# FINAL DRAINAGE REPORT

## CONSTITUTION STORAGE DEVELOPMENT

El Paso County, Colorado

*PCD Filing No.: PPR-2224*

**Define Zones and Basin Geometry**

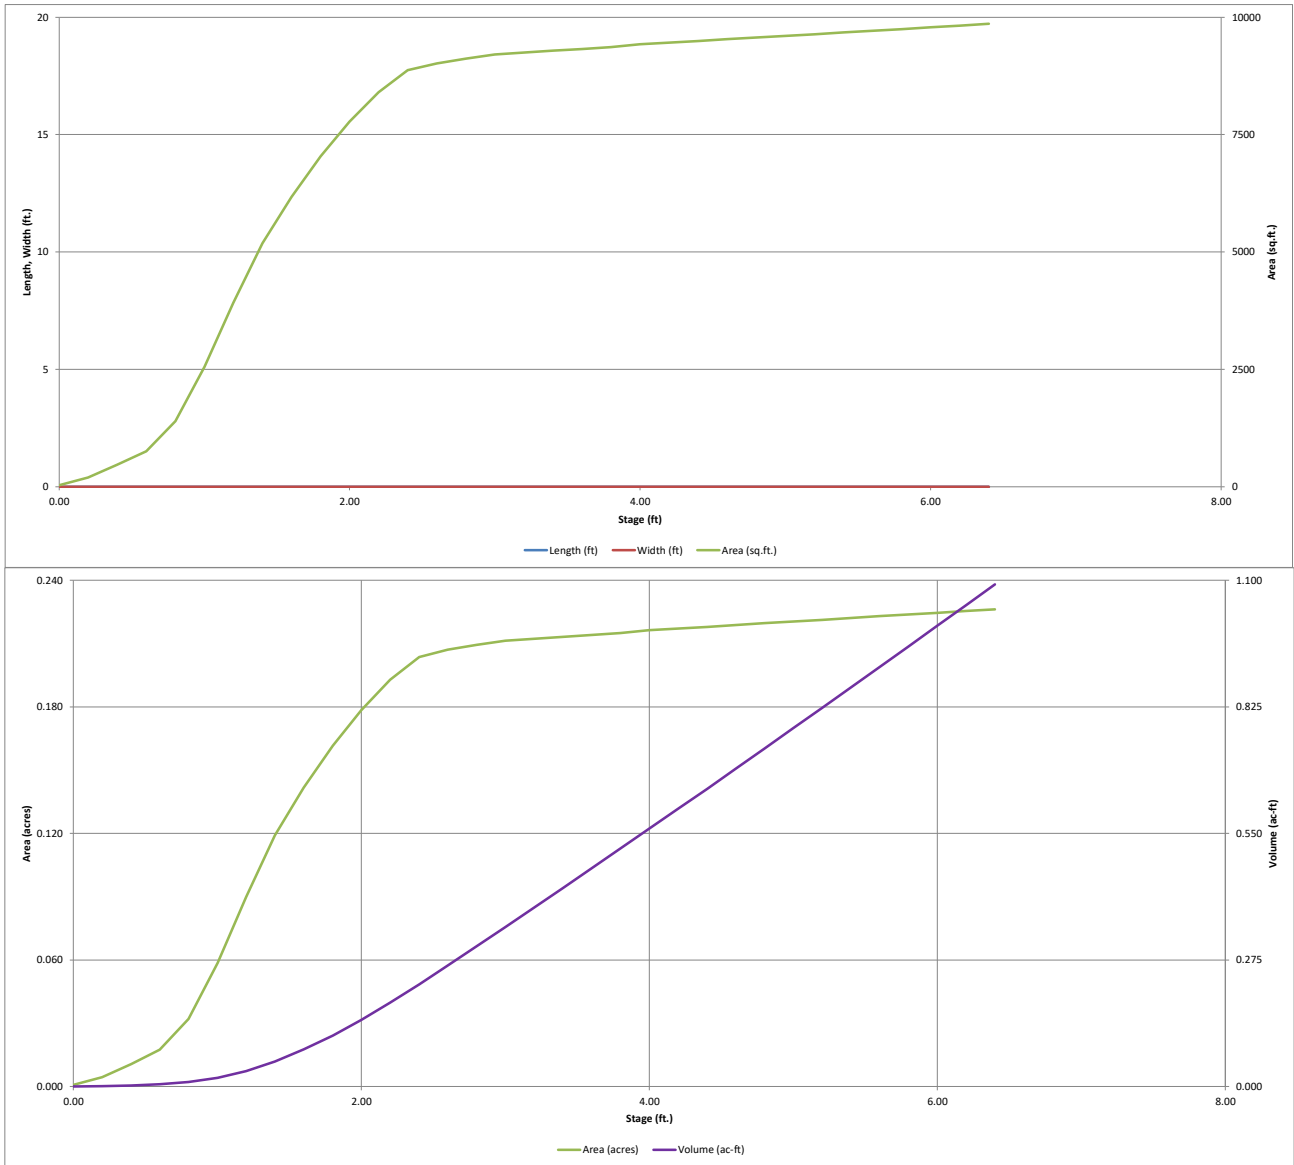
Unresolved. Provide detail for outlet structure and orifice plate.

**Routed Hydrograph Results**

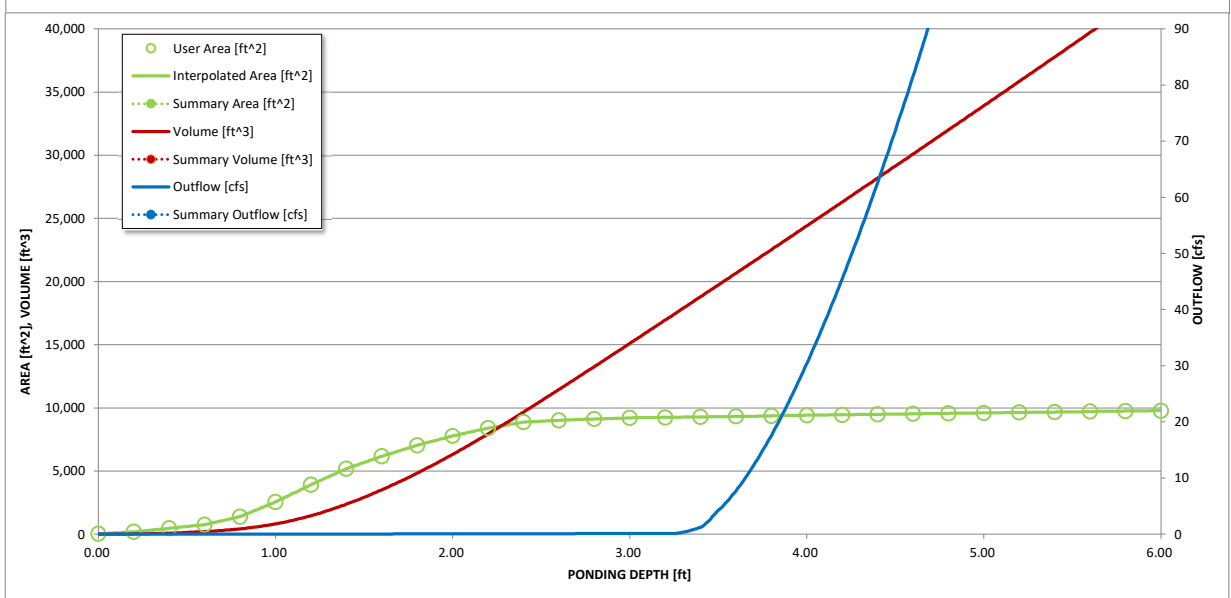
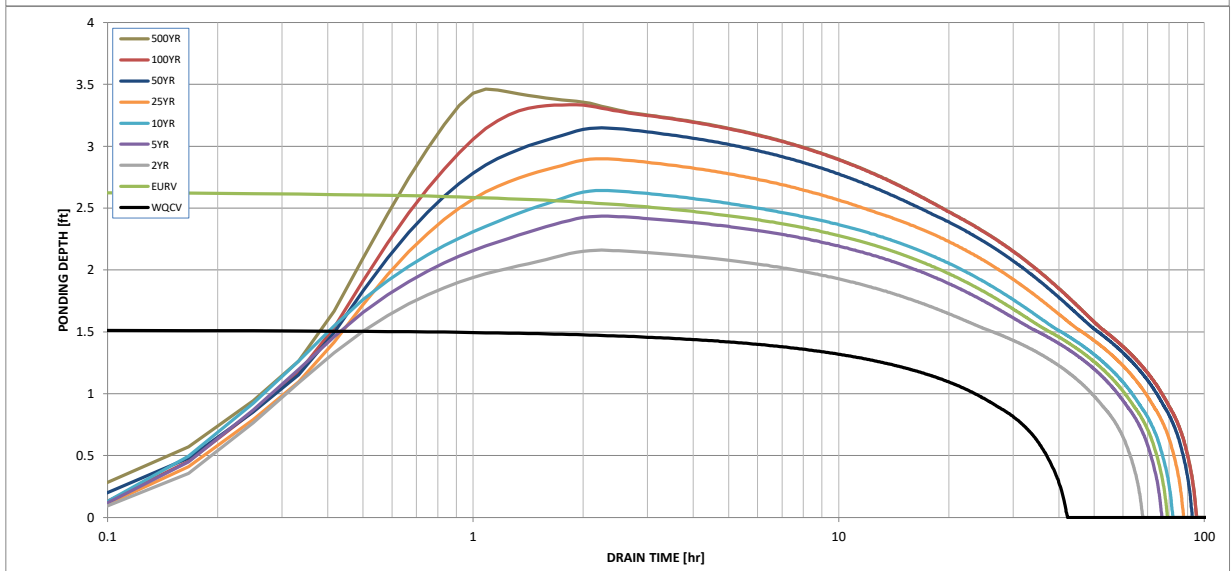
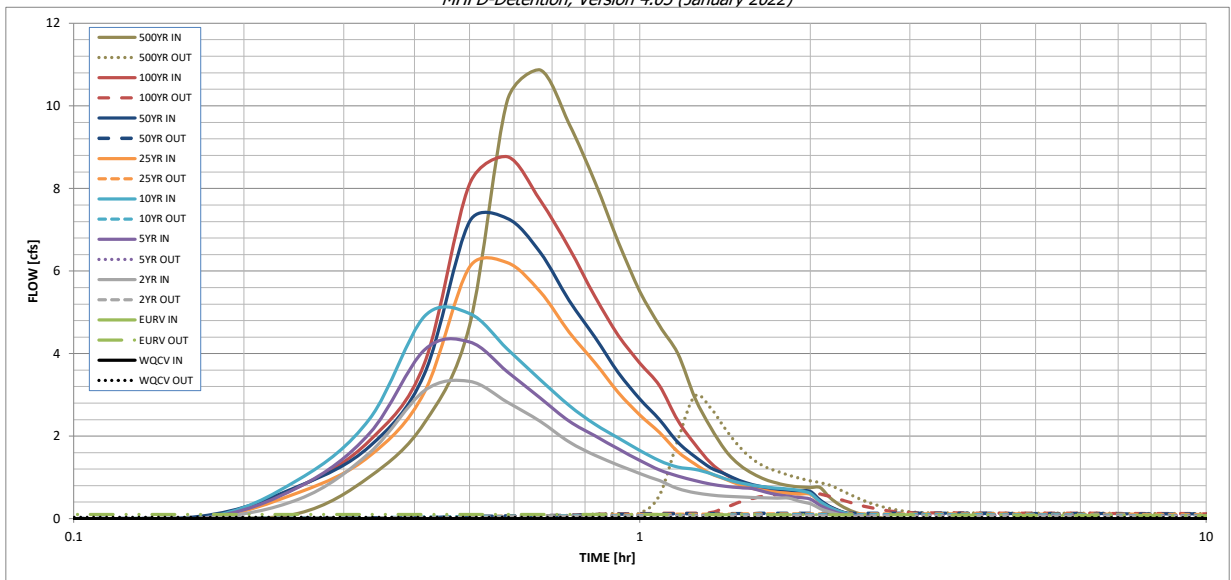
Unresolved. Provide details for spillway.

Unresolved. Ratio should be closer to 1. Revise.
